SUPPLEMENTARY WATER MANAGEMENT REPORT

Client — Warriewood Developers Pty Ltd
Project Title — Proposed Residential Development
Project No. — SW24353
Date Issued — 08/11/2024

& Response to Contentions

DR01 - LONGITUDINAL SECTION
HORZ SCALE 1:500
VERT SCALE 1:250

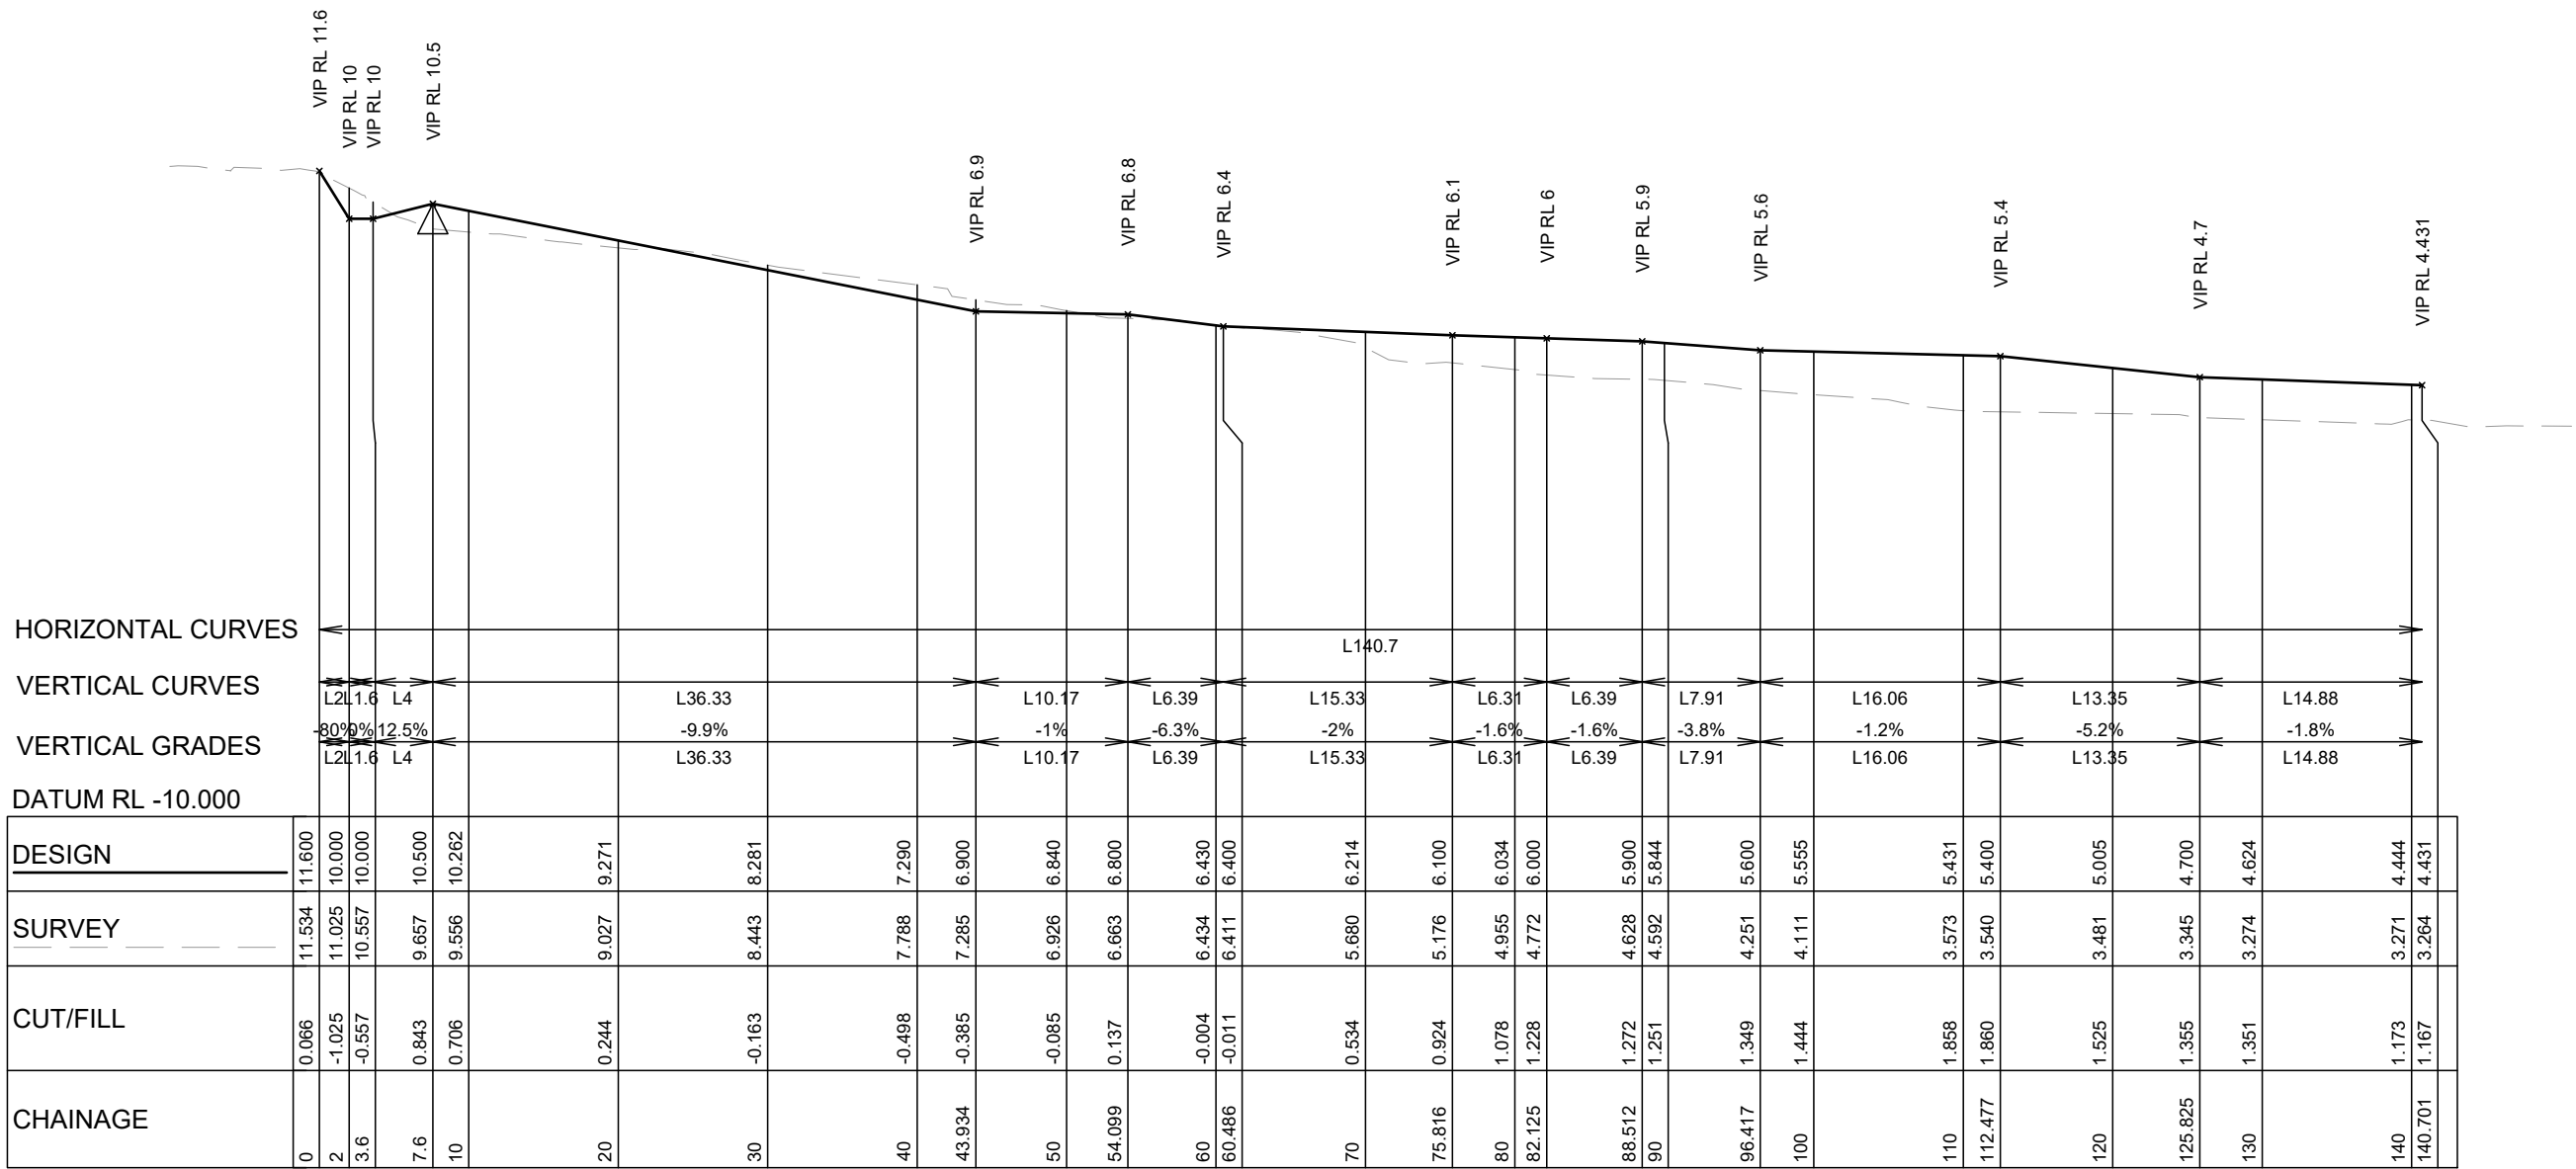
3.a.iv	<p>The Applicant has not provided sufficient detail with respect to the design of the overland flow path over the proposed stormwater line within the existing drainage reserve. Cross sections are required along the overland flow path to detail the 1& AEP Top Water Levels and to ensure that all habitable areas are a minimum of 500mm above these levels.</p>	<p>We refer to our response to contention 3.a.ii and note that a revised design and associated DRAINS model has been prepared which demonstrates the system depicted on our revised civil engineering plans can sufficiently capture and convey 100 Year ARI + CC30 flows through the site.</p>

LONG SECTION (100YR ARI + CC)
DRAINAGE LINE 3

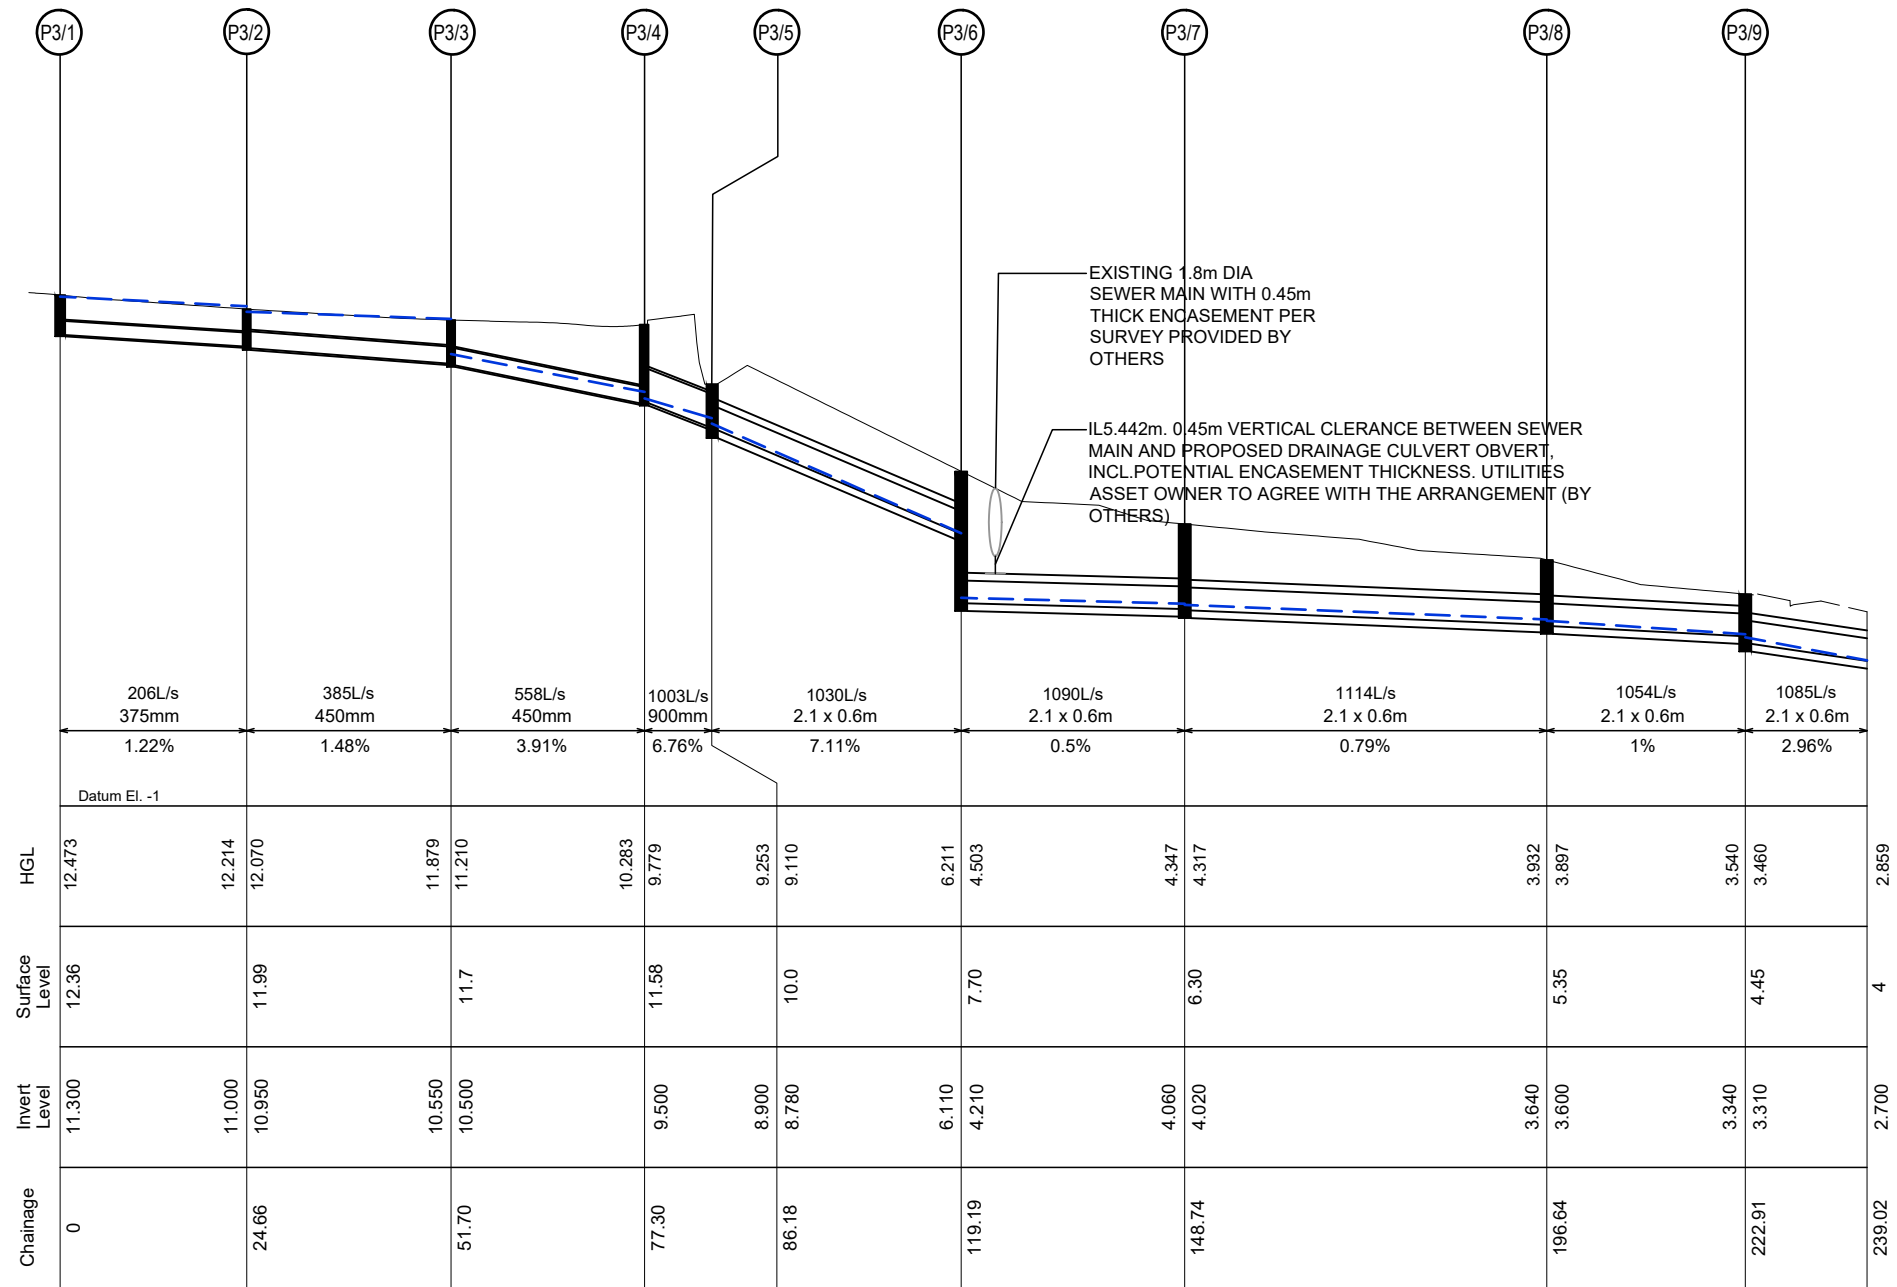
3.a.vii	The development application is not supported by sufficient long sections of stormwater lines, required to detail surface levels, the location of the pipe, the hydraulic grade line, velocities, and flows.	We refer to our revised civil engineering plans and note that a revised stormwater drainage long section has been document. The long section includes a hydraulic grade line analysis for the 100 Year ARI flows plus Climate Change.

OUTLET AND ENERGY DISSIPATION SWALE - BASIN 2
NOT TO SCALE

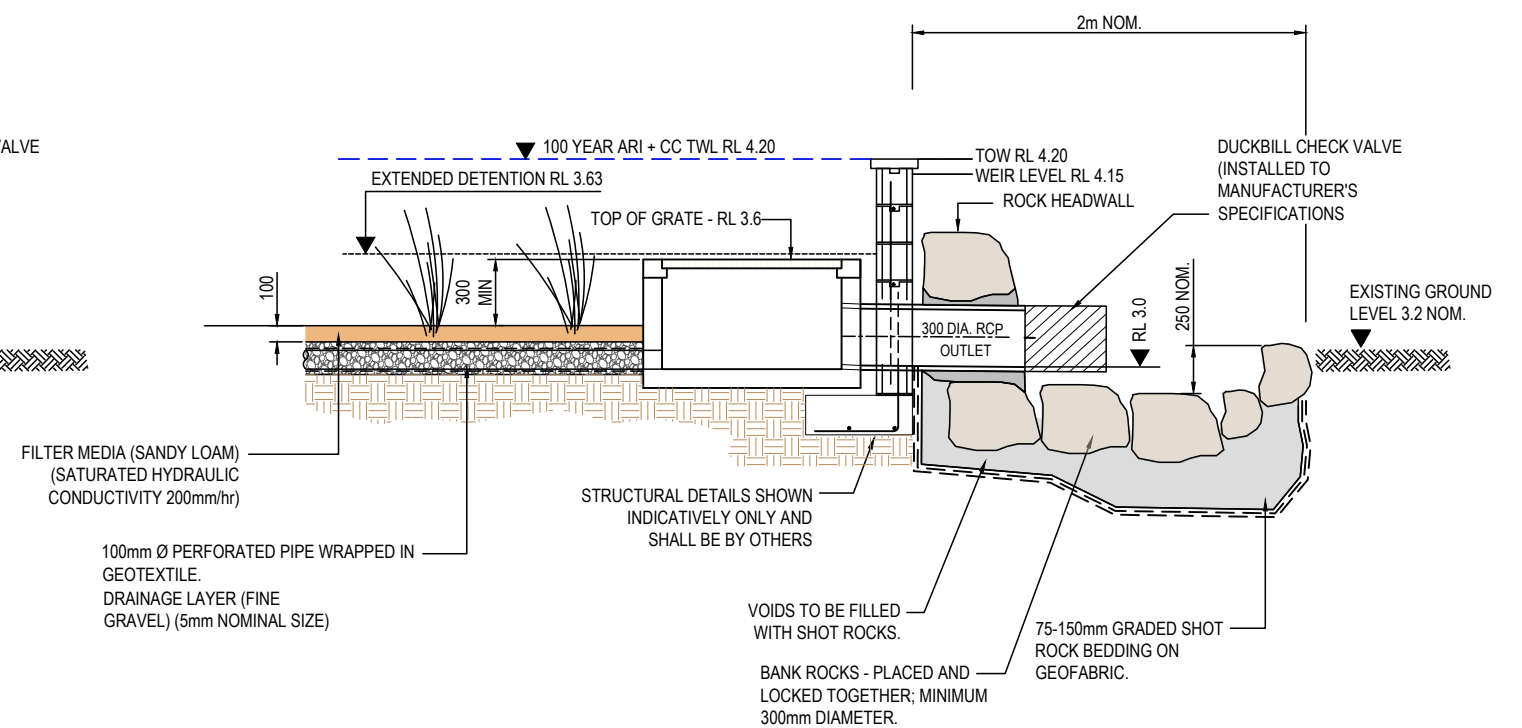
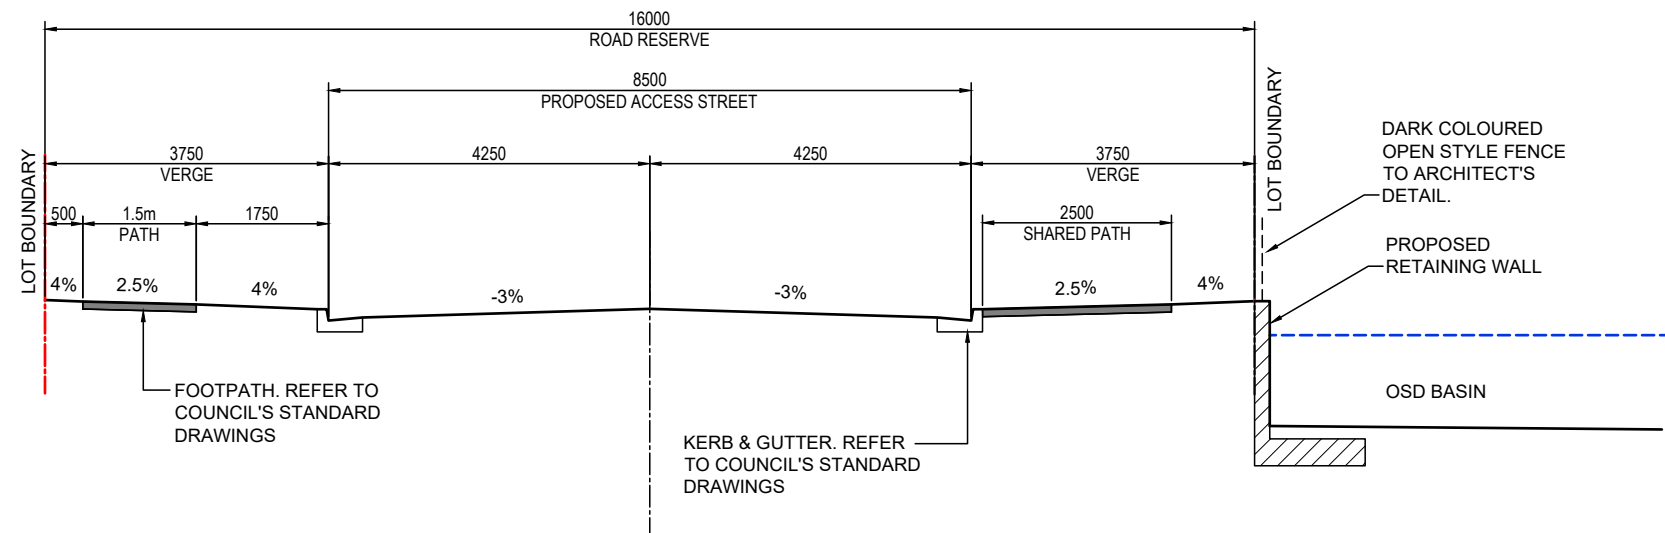
3.a.xiv	The proposed infiltration basin has a weir to control the outflow. The Applicant has not demonstrated that this is an appropriate outlet method in light of the groundwater dependent EEC along the creek line.	We refer to our document CC230177, sheets C1.00 to C4.03 (26 sheets), revision C, dated 6 March 2024 and note that weir overflows are proposed to an energy dissipation swale. This method has been discussed with Council's representatives in concept and are documented on our revised civil engineering plans. We understand this is a satisfactory outcome resulting in minimal impact to the EEC.
